Access Compliance Report

Public Rights-of-Way

Intersection ID: 11423	Main Street: S_SUMMIT_AV	Cross Street: W_4TH_ST_EXT	Location: SE
ADA ID: FA406087FAC8	Ramp Type: Directional1	Initial Pass/Fail: Pass	Overall Compliance: No
		Severity Score: 0

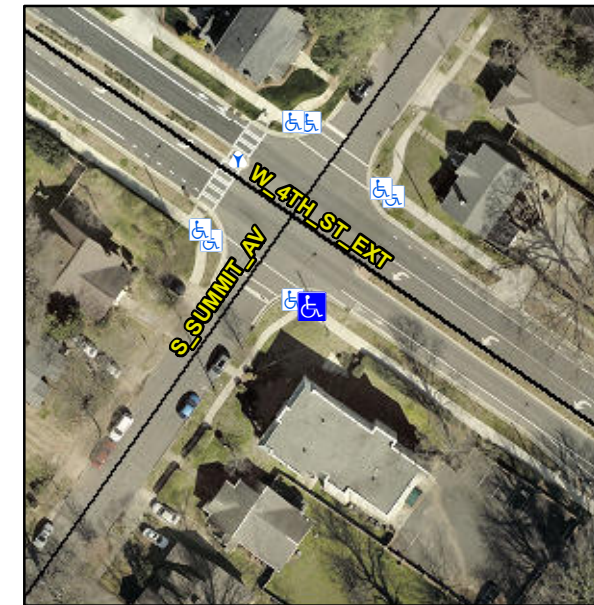
R304.5.3

Compliance	Description	Data	Compliance	Description	Data
N/A	Ramp Length (in)	54.5	Yes	Grade Break?	Yes
Yes	Ramp Width (in)	70.0	No	Grade Break Slope (%)	8.3
Yes	Ramp Slope (%)	5.1	No	Grade Break XSlope (%)	3.1
Yes	Ramp XSlope (%)	0.5			
Yes	Flare Type LT	N/A	Yes	Flare Type RT	N/A
N/A	Flare Slope LT (%)	N/A	N/A	Flare Slope RT (%)	N/A
N/A	Flare Traversable LT?	No	N/A	Flare Traversable RT?	No
Yes	Landing Length (in)	71.0	Yes	DWS Provided?	Yes
Yes	Landing Width (in)	72.0	Yes	DWS Contrast?	Yes
Yes	Landing Slope (%)	1.1	Yes	DWS Length (in)	24.0
Yes	Landing X Slope (%)	1.2	Yes	DWS Full Width?	Yes
N/A	Landing Curb? (Y/N)	No	Yes	DWS Offset LT (in)	18.0
N/A	Shared Landing?	Yes	Yes	DWS Offset RT (in)	0.0
Yes	Gutter Ponding?	No	Yes	Gutter Slope (%)	2.0
Yes	Gutter Lip Ht (in)	0.0	Yes	Gutter X Slope (%)	0.9
N/A	Painted X Walk1?	No		Road Slope (%)	2.3
	X Walk 1 Direction	To NE		Road X Slope (%)	2.6
	X Walk 1 Width (in)	N/A		Clear Space?	Yes

Remove & Replace Entire Ramp.
